PLAN COMMISSION MEETING NOTICE AND AGENDA Thursday, February 15, 2024 6:00 PM

REPORT TO THE PLAN COMMISSION

Project Name: Radiant Plastic Surgery Comprehensive Master Plan Amendment, Rezoning, and Site & Building Plan Review

The proposed use of the 7,600 square foot building will be unchanged, storage of goods consumed in real estate management and real estate construction related businesses. Hours of operation would be unchanged; 7:00am – 7:00 pm, Monday through Saturday.

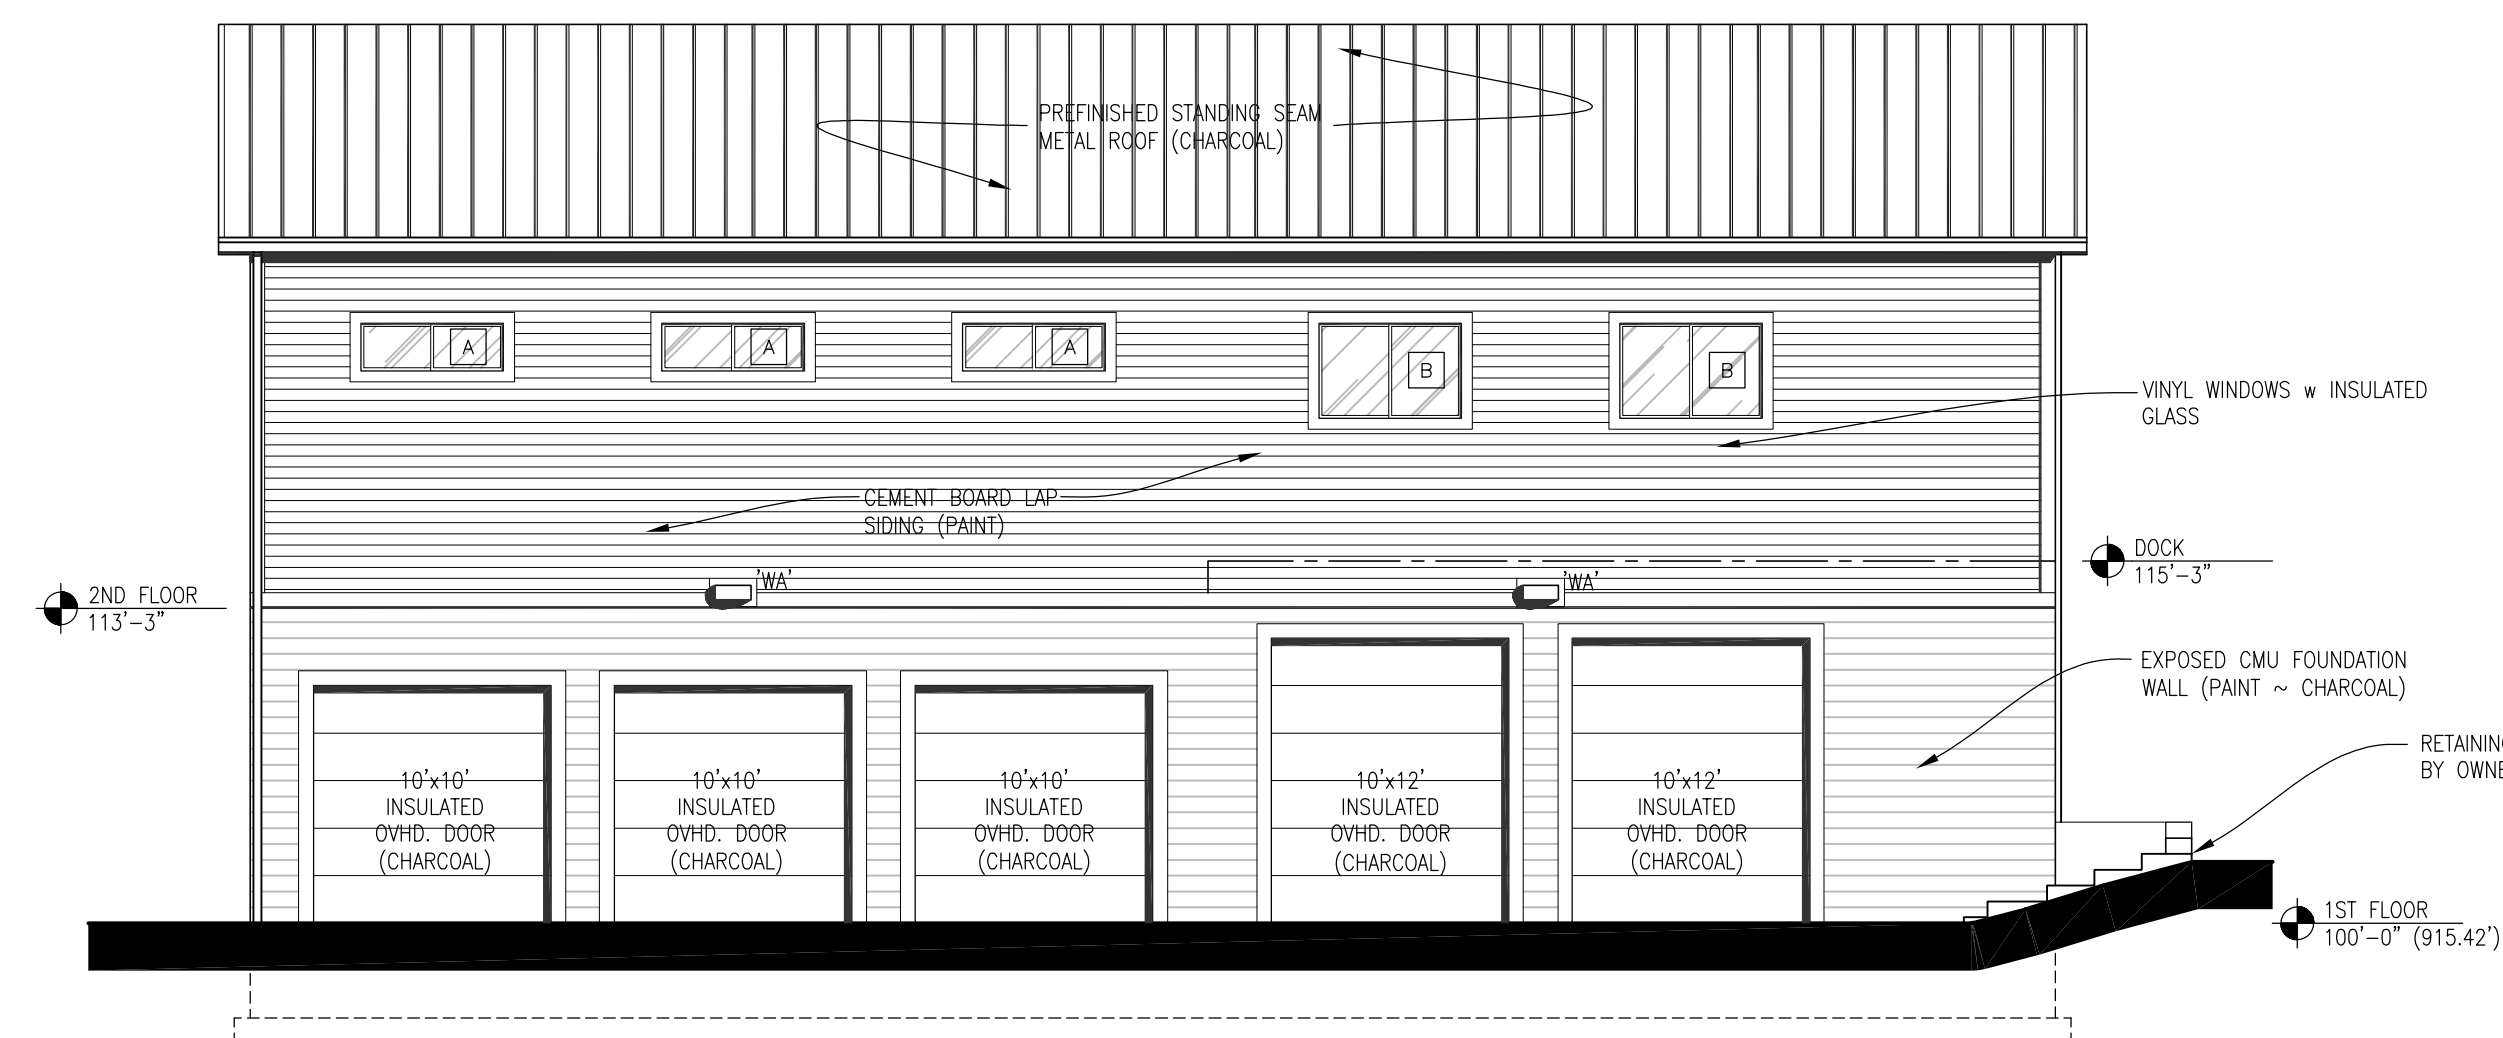
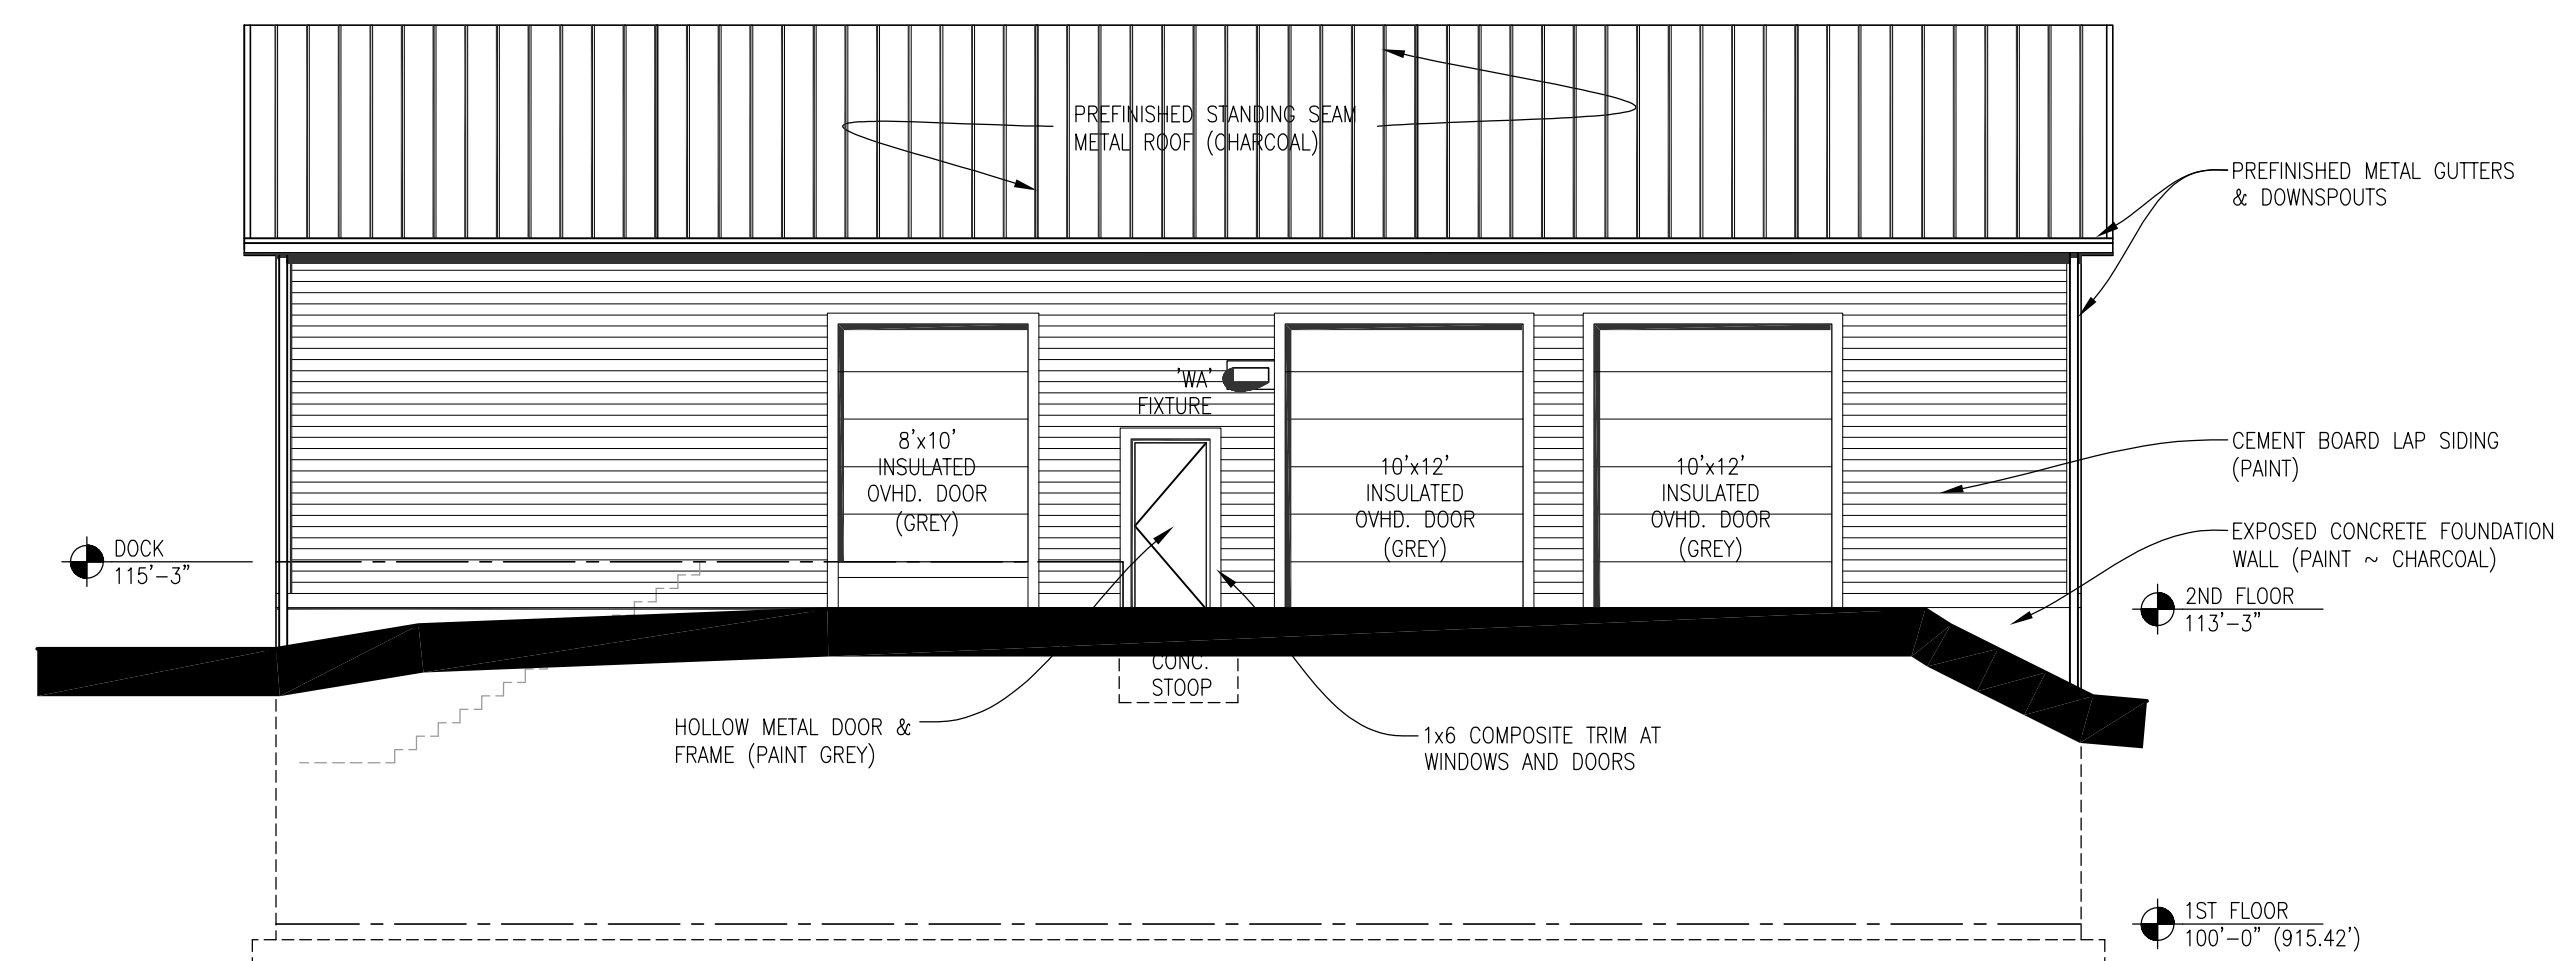
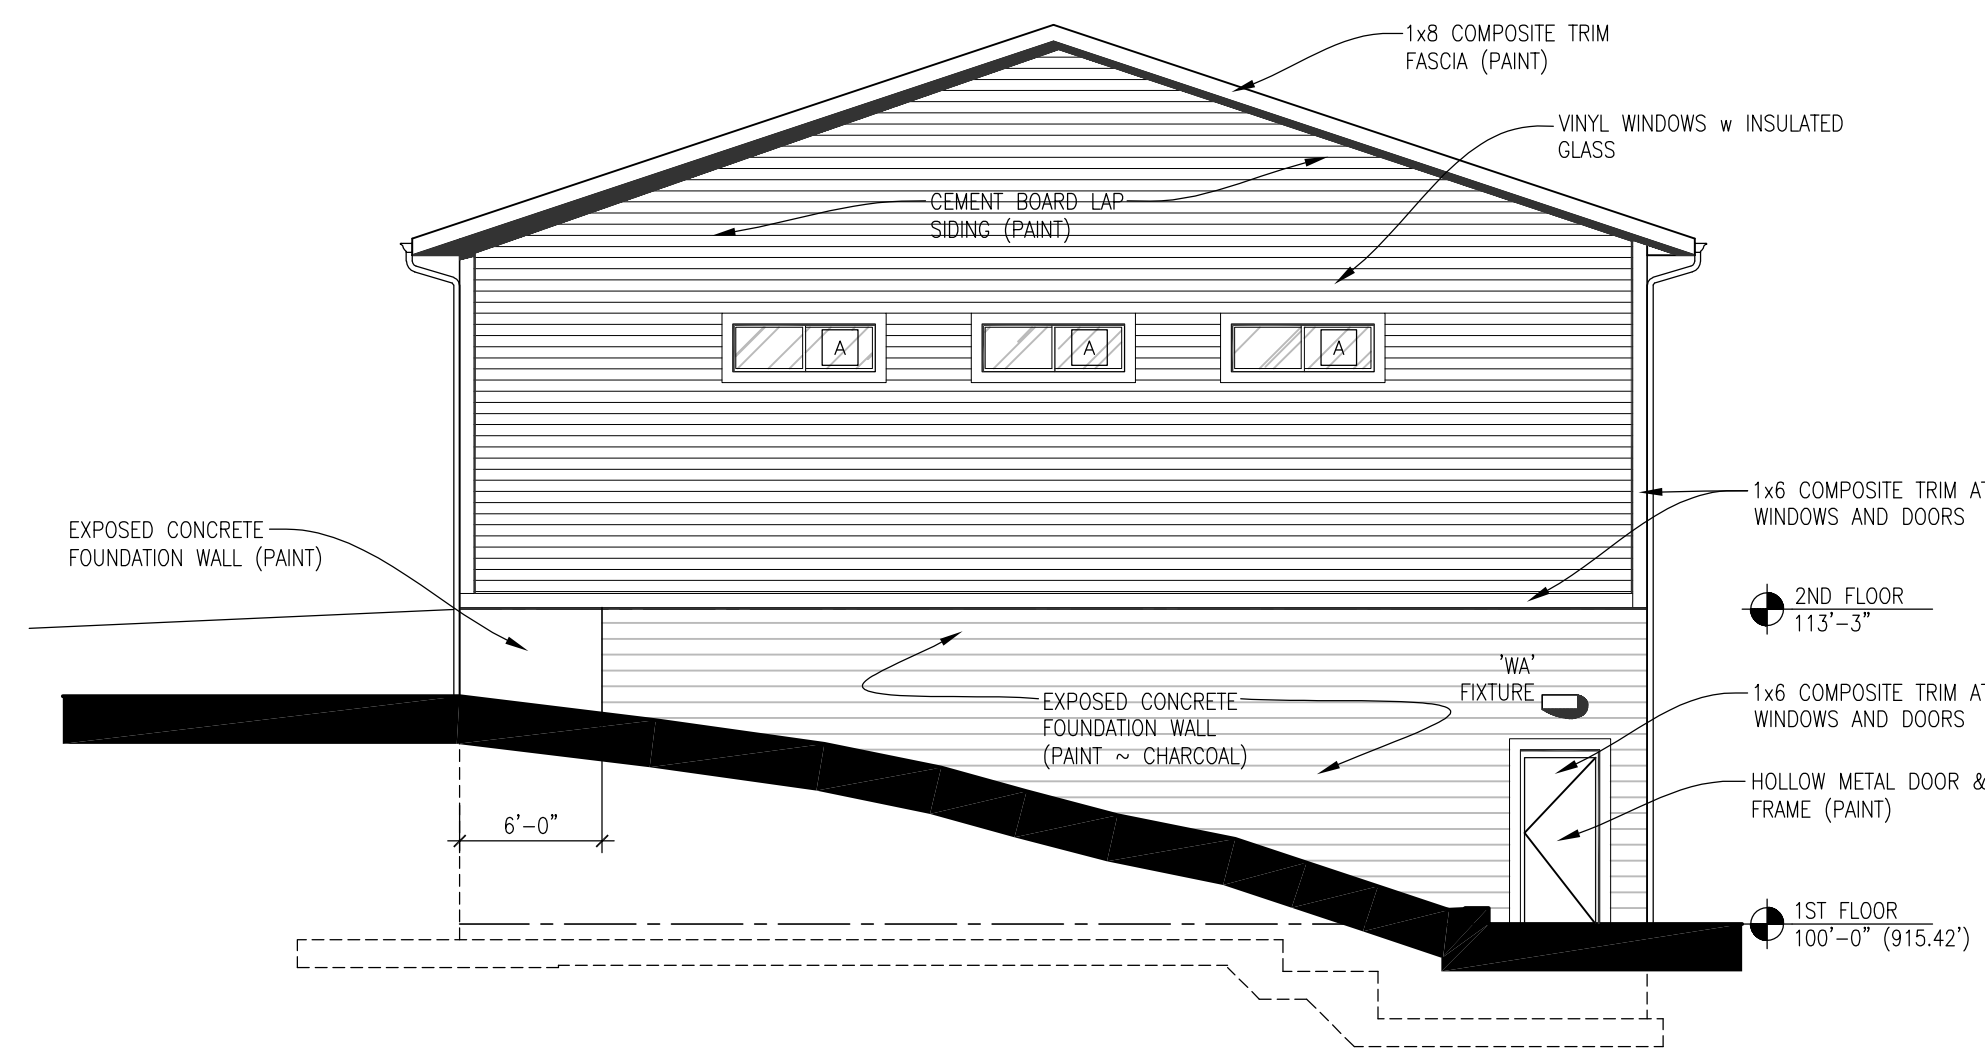
The building is currently under construction, and the applicant is now requesting allowance to increase the height of the building by 4-feet. In conjunction with this change, the height of the overhead garage doors on the north elevation will be two feet taller. Otherwise, building materials and number of doors and windows are not changing.

This request is to add 4ft of height to the building taking the second level wall height from 12ft to 16ft. The additional head space will allow more flexibility in storing some of our larger vehicles and materials.

Staff recommends approval of the request to increase the height of the storage building located at N4W22540 Bluemound Road by four feet as illustrated on the attached plans.
